Installation of Back Stop Pawl

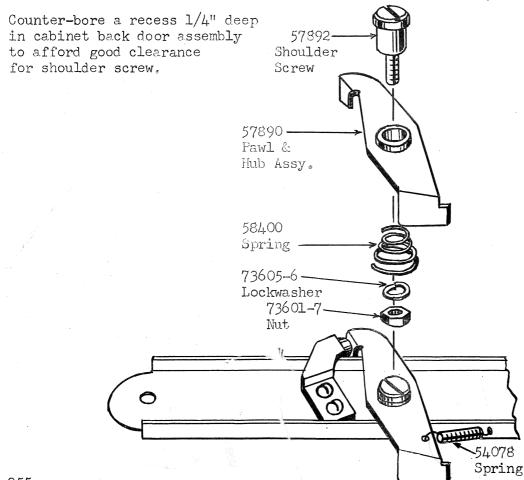
Where it is found desirable to replace #57651 Lever and Pin Assembly with #57890 Pawl and Hub Assembly, this may be accomplished by drilling one hole in the Channel and Bracket Support Assembly.

Drill hole .171" diameter (or #17 drill) on center line. This locates 3/8" below and 3/32" toward selector shaft from center of the hole used in mounting first back stop pawl. We are supplying a template to locate drilling point.

Remove old pawl. For convenience also remove the bracket and rubber bumper which will be used again after drilling hole.

Mount #57890 Pawl and Hub Assembly as indicated in sketch below. A Spring, #58400, is mounted with small section next to the pawl as indicated.
